VIRGINIA ELECTRIC AND POWER COMPANY
RICHMOND, VIRGINIA 23261

VIRGINIA ELECTRIC AND POWER COMPANY
SURRY POWER STATION UNITS 1 AND 2
GENERIC LETTER 96-06 ASSURANCE OF EQUIPMENT OPERABILITY AND
CONTAINMENT INTEGRITY DURING DESIGN-BASIS ACCIDENT CONDITIONS
REQUEST FOR ADDITIONAL INFORMATION

RESPONSE TO REQUEST FOR ADDITIONAL INFORMATION GENERIC LETTER 96-06

FIGURE 1

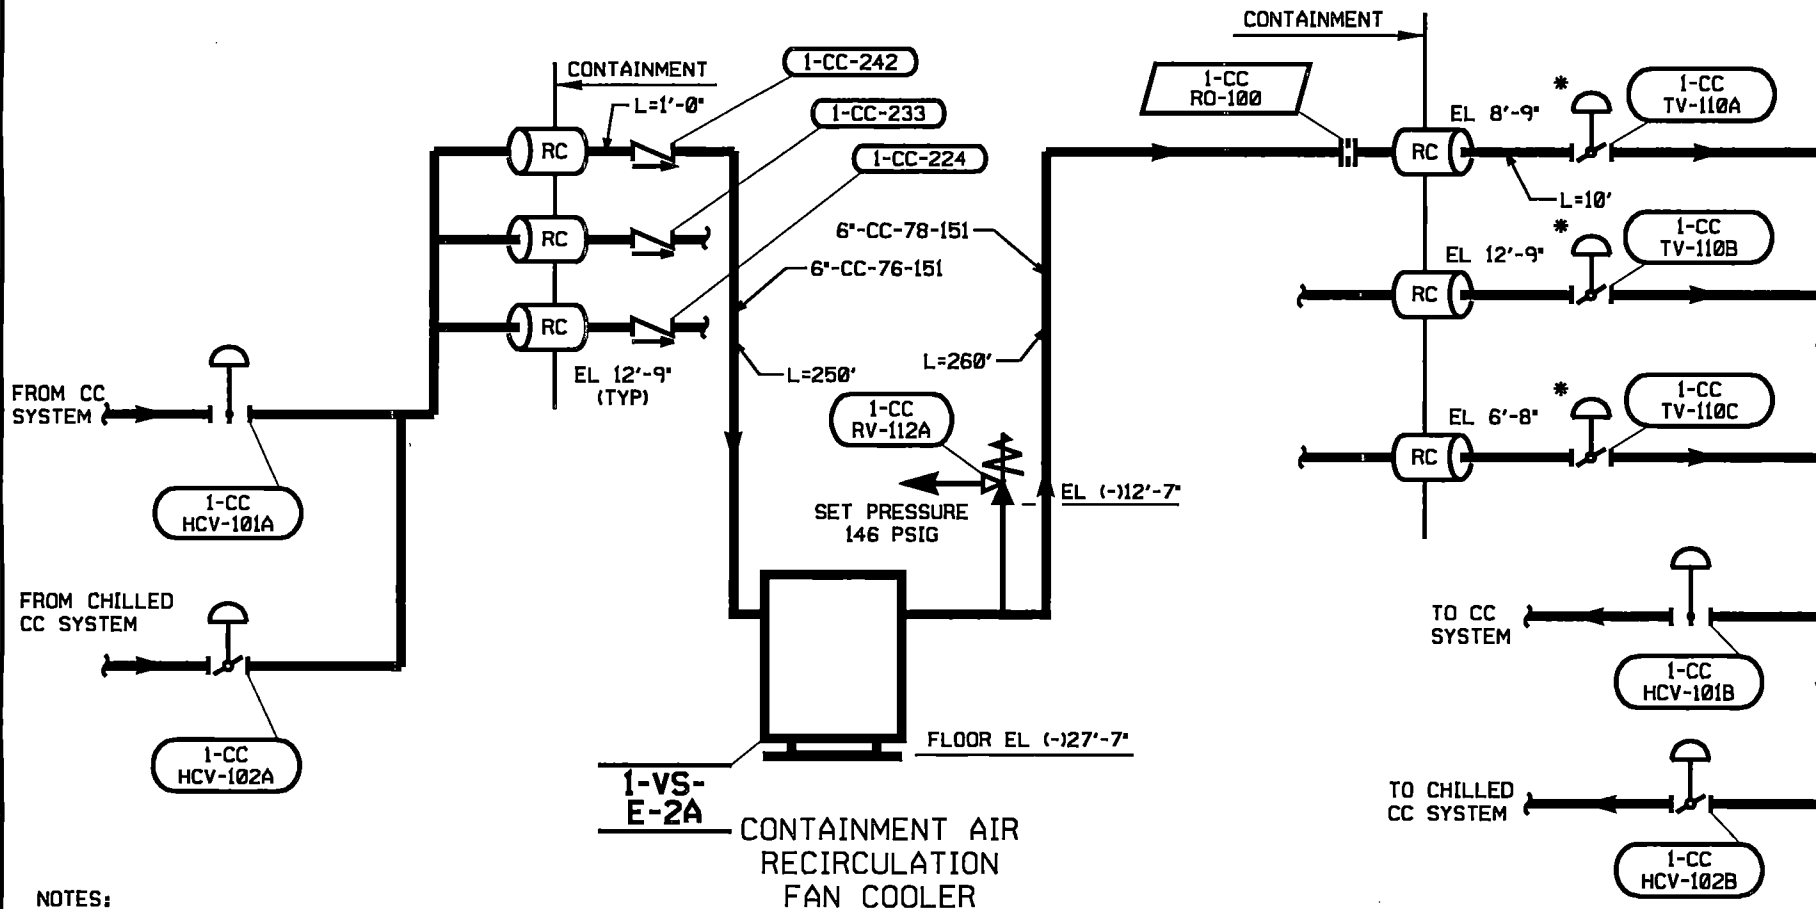
Implementing measures to assure that water hammer will not occur, such as prohibiting post accident operation of the affected system, is an acceptable approach for addressing the water hammer concern. However, all scenarios must be considered to assure that the vulnerability to water hammer has been eliminated. Confirm that all scenarios have been considered, including those where the affected containment penetrations are not isolated (if this is a possibility), such that the measures that have been established are adequate to prevent the occurrence of water hammer during (and following) all postulated accident scenarios.

Provide a simplified diagram of the affected systems, showing major components, active components, relative elevations, lengths of piping runs, and the location of any orifices and flow restrictions.

During a DBA the cooling water flow through the air recirculation coolers is isolated by the return containment isolation trip valves 1(2)-CC-TV-110A, B & C (210A, B & C). The cooling water supply containment isolation valves are 1/2-CC-224, 233, 242. The air recirculation coolers are located in the lowest elevation in containment (floor elevation -27'-7") as shown on Figure 1.

With the recirculation air cooler water flow isolated by the containment isolation valves, it is postulated that containment ambient heat is transferred to the trapped fluid through the exposed recirculation air coolers. As the bulk temperature of the isolated fluid in the coolers and the 6 inch supply and return piping rises, the internal pressure increases. Each air recirculation cooler is protected by a thermal relief valve, 1(2)-CC-RV-112A, B & C (212A, B & C), which is set at 146 psig. If the trapped fluid expands enough to raise the pressure to the set pressure of the cooler relief valve, then the relief valve will lift and reset at a lower pressure. If containment conditions warrant, heat would again be transferred to the exposed cooling coils and the set pressure of the relief valve may be reached again. This scenario would continue until not enough heat could be transferred to the trapped fluid to cause the relief to lift. It should be noted that no steam voids are formed due to the pressure and associated high saturation temperature of the fluid in the coolers and piping during this time. The corresponding saturation temperature associated with a pressure of 146 psig is 364°F. In addition, when the cooling water flow is restored through the coolers, the cooling water would be at approximately 90 psig. At this pressure (associated saturation temperature of 331°F), no steam voids would exist in the cooler piping.

Response – A complete FMEA was determined not to be necessary. The Containment Spray and Recirculation Spray systems perform containment cooling and depressurization during a DBA. The cooling water flow to the containment air recirculation coolers is isolated via containment isolation valve closure as shown on Figure 1. At such time that cooling water flow is re-established to the containment air recirculation coolers, steam induced water hammer caused by steam void collapse in the coolers will not occur due to a reduced containment air temperature compared to the higher saturation temperature of the fluid in the cooler piping. Even if a containment air recirculation cooler relief valve did not reseal properly, the component cooling water surge tank would provide inventory replacement and indication of inventory loss. Therefore, it was concluded that water hammer and two phase flow is not a concern during a DBA, and a complete FMEA is not warranted.

Response - Figure 1 provides a simplified diagram of the affected systems as requested.
